NOTICE OF OPEN MEETING
AGENDA
PLANNING AND ZONING COMMISSION
City of Moberly
City Council Chambers – Moberly City Hall
101 West Reed Street
May 28, 2024
6:00 PM

Subject: *451 Sparks Ave Site Plan Review*

Subject: *1145 S Morley St Site Plan Review*

Conceptual Site Plan for 451 Sparks Avenue

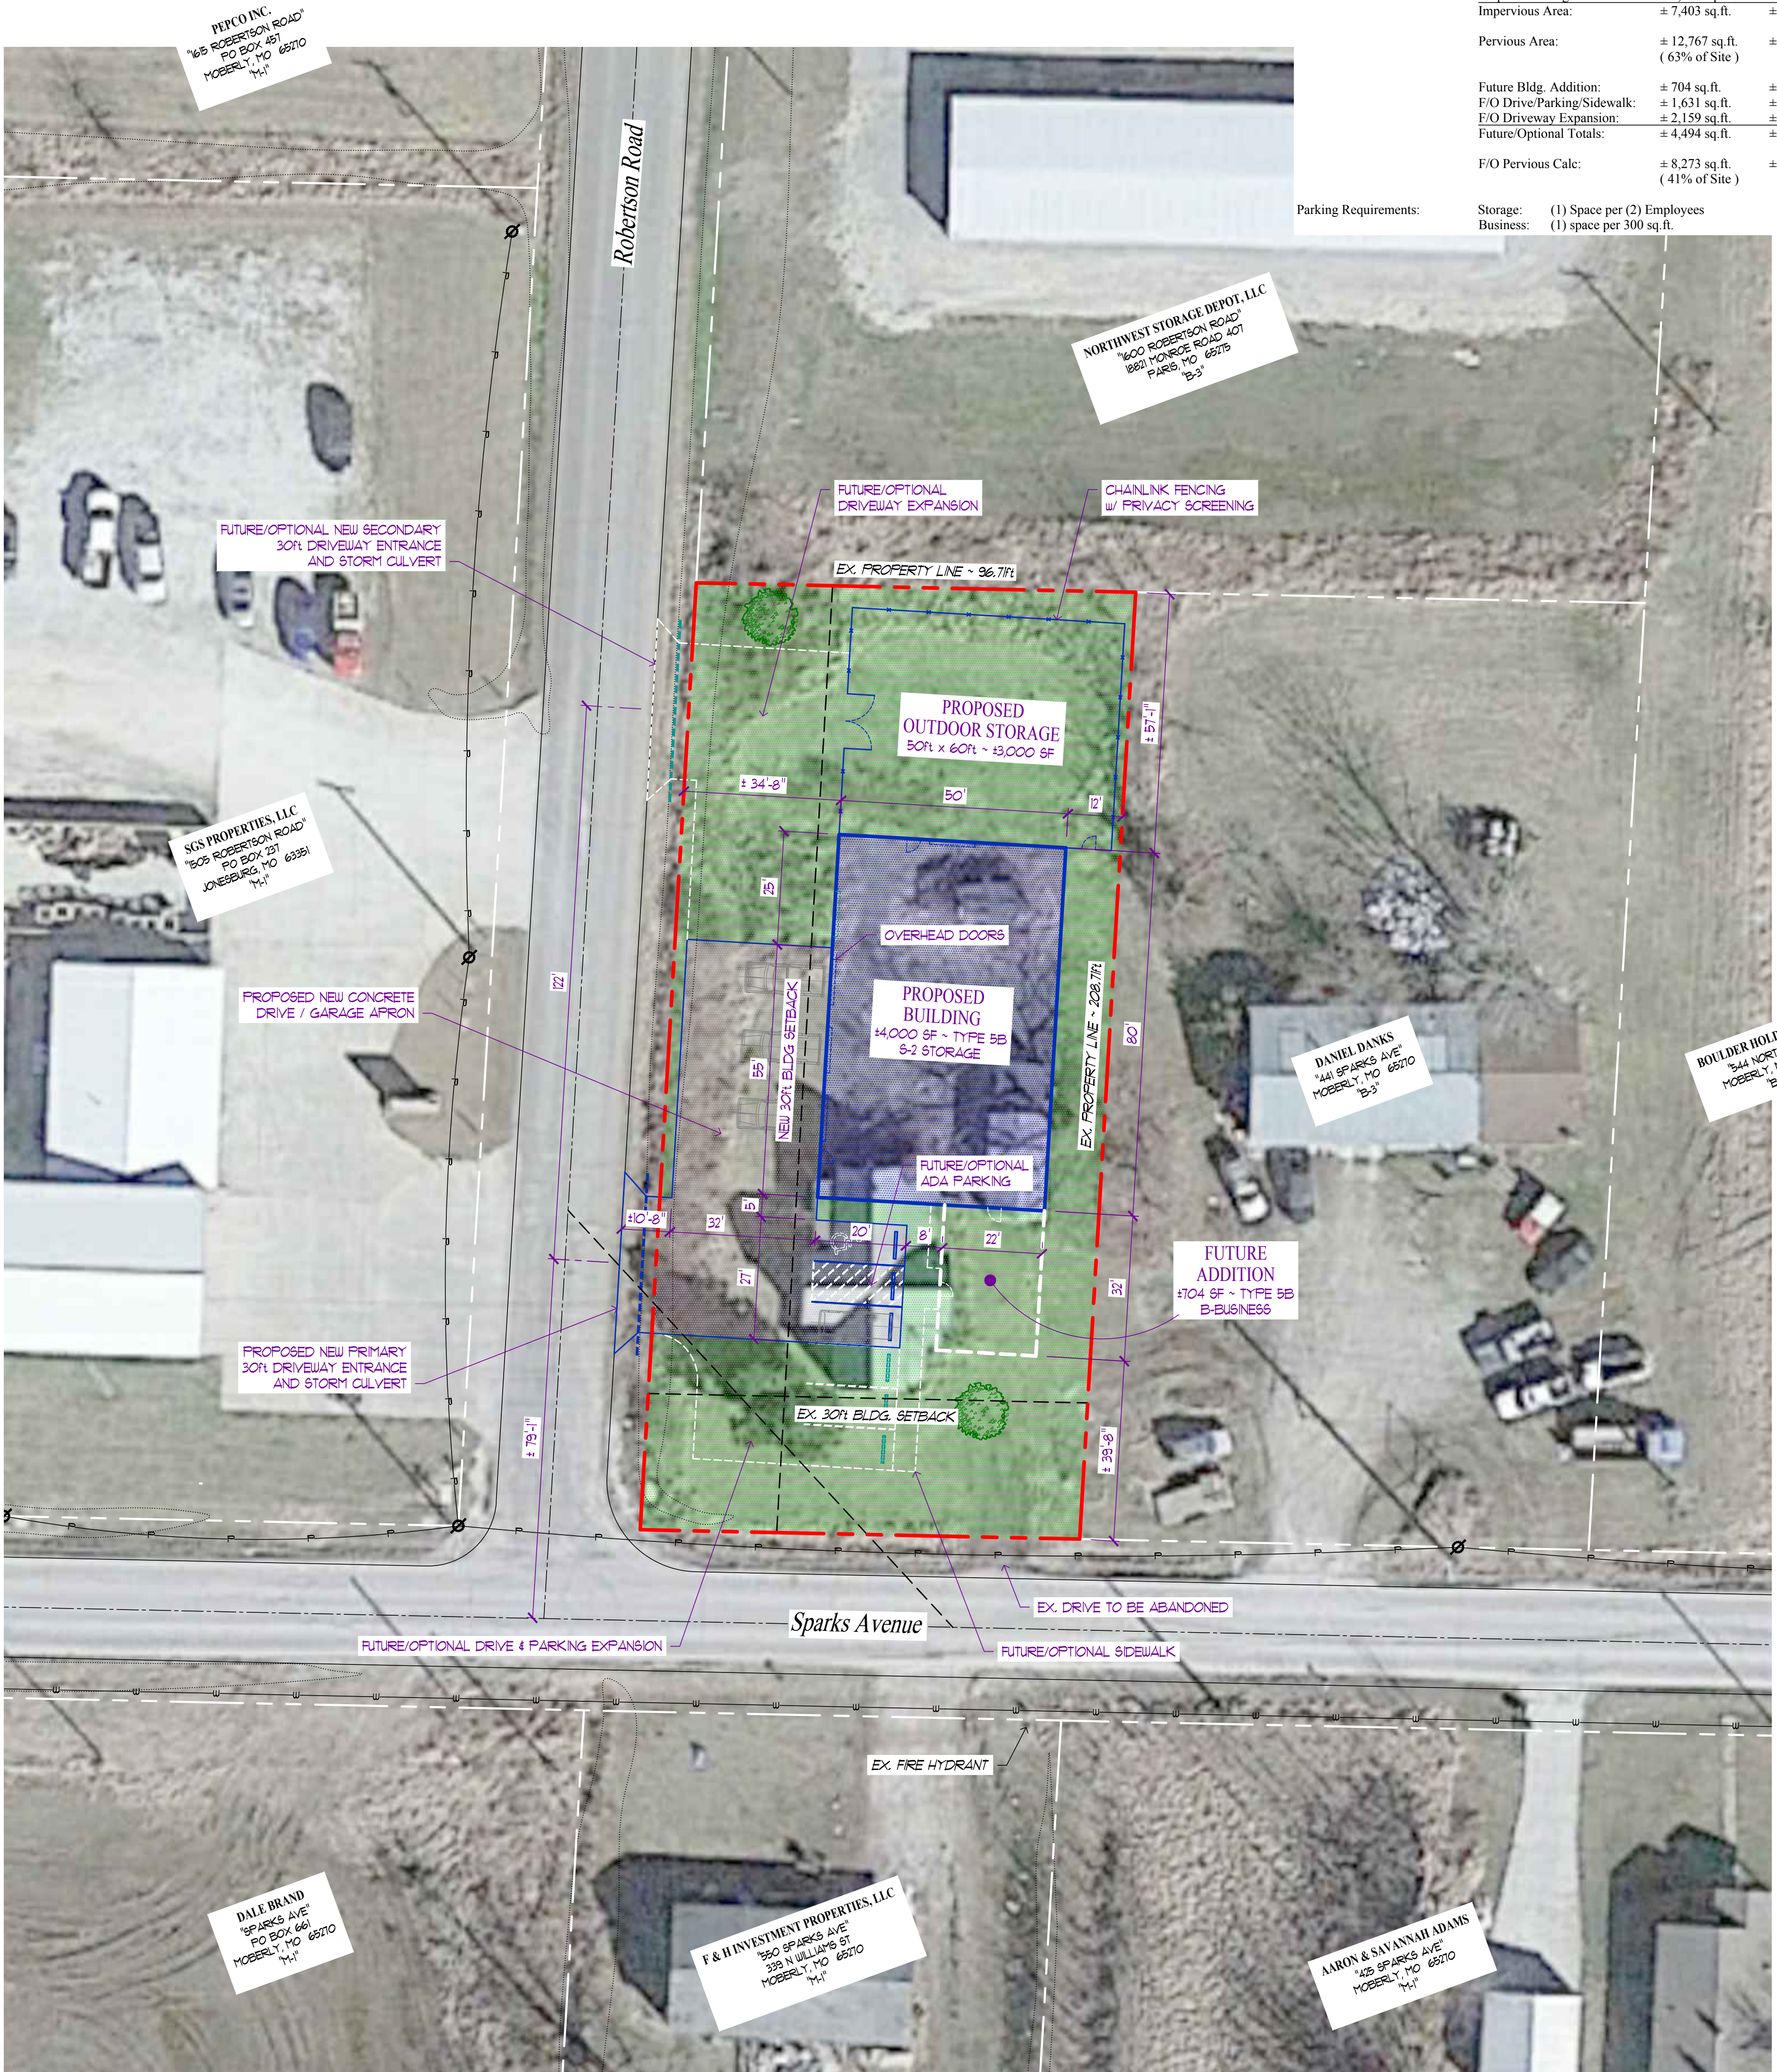
Landscaping design: Proposed plan accommodates necessary parking and reuse of existing landscaping design, however it will clean up existing perimeter brush.

Public areas: There is adequate off-street parking for vehicles and room for pulling in and out with future growth for an office space. Optional secondary entrance for north end of lot indicated on plans.

Pedestrian traffic: There are no existing public sidewalks in the area for either street frontage. No indication of intent to install public sidewalks. No indication of intent to do fee in lieu of? (Recommended)

Building type: Wood Framed Metal clad building with overhead doors and metal roof.

City staff recommend acceptance and approval of the Site Plan as presented with sidewalk fee in lieu of.

Conceptual Master Site Plan for Redeemer Church

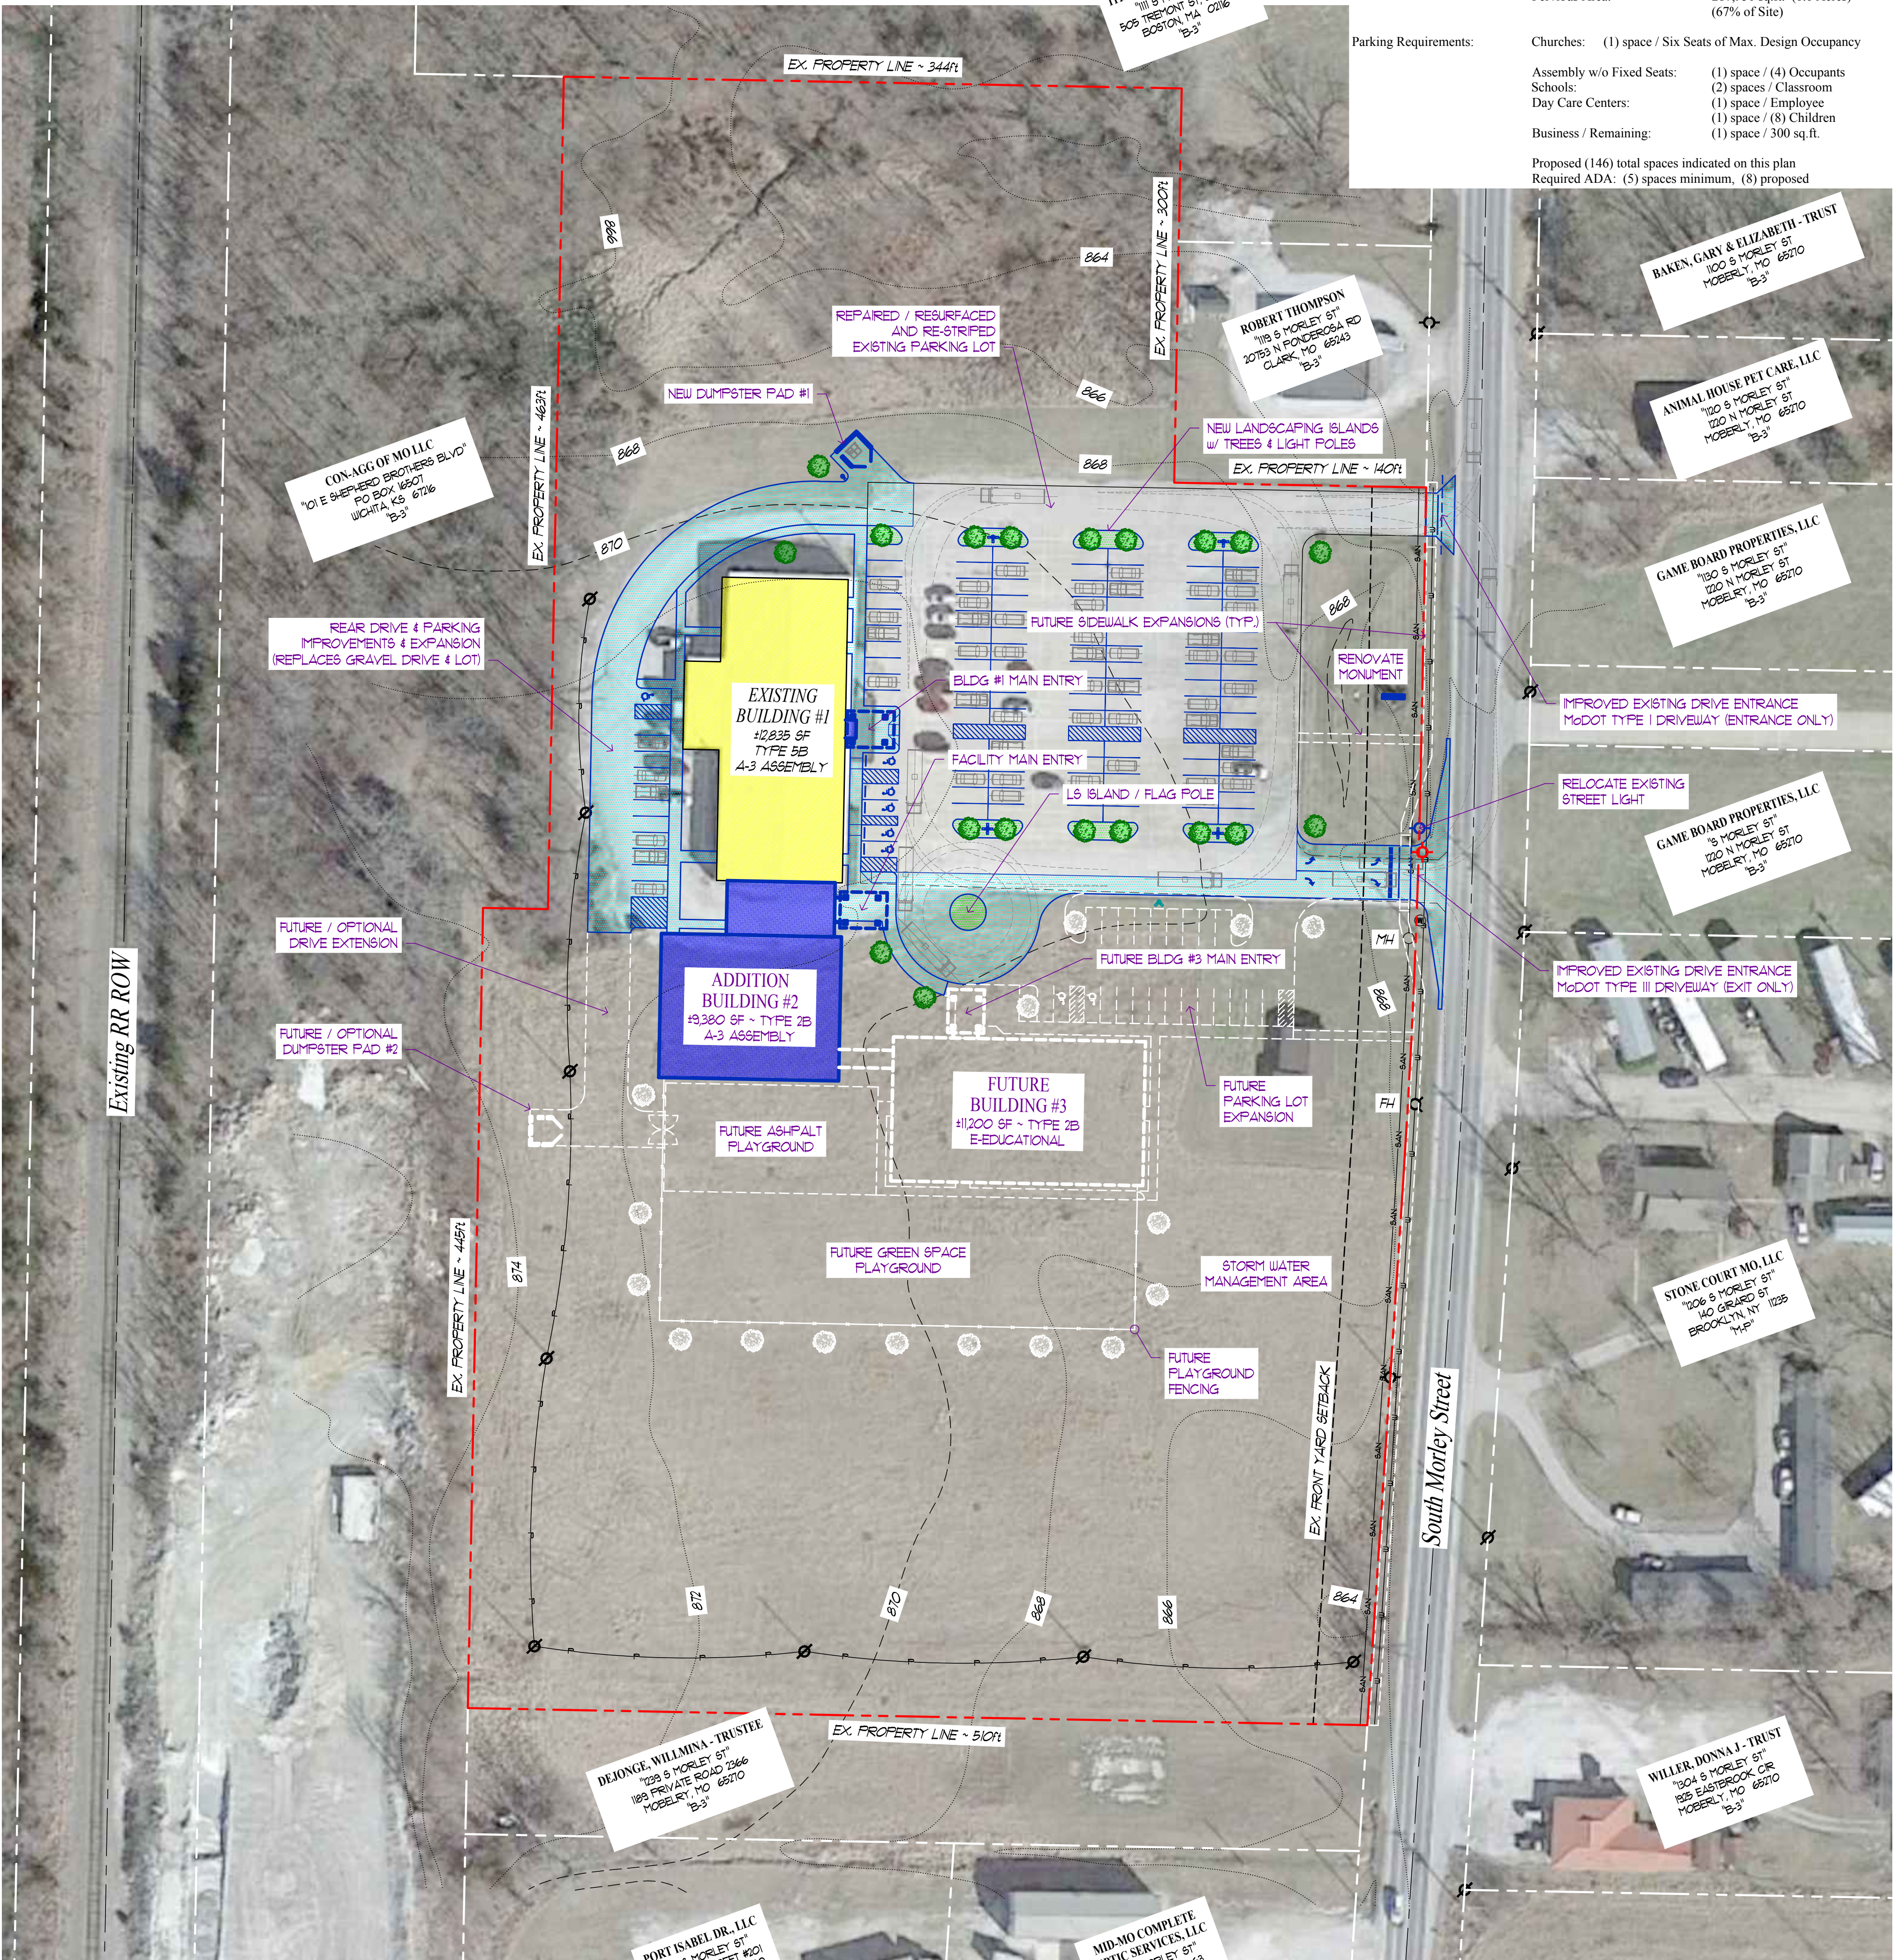
Intended Use: This master plan is designed to phase in the use of the property by Redeemer church. Starting with Sunday school and Worship Hall. Future development and parking to be added for future educational building at time of growth.

Landscaping design: Property plans are in current compliance with parking and landscaping ordinances. Changes indicated will bring the site into compliance at completion.

Public areas: Indications show that the north entrance will be enter and the south egress to be exit only. This should help with flow of traffic due to increased activity on select days. Adequate paths, from parking to the building entrances, are provided.

Pedestrian traffic: There are no existing public sidewalks in the area for street frontage. Plan is to install public sidewalks and sidewalks to the buildings and structures along perimeter of parking lot when sidewalks are installed along S Morley St.

City staff recommend acceptance and approval of the Site Plan for the property associated with 1145 S Morley St.
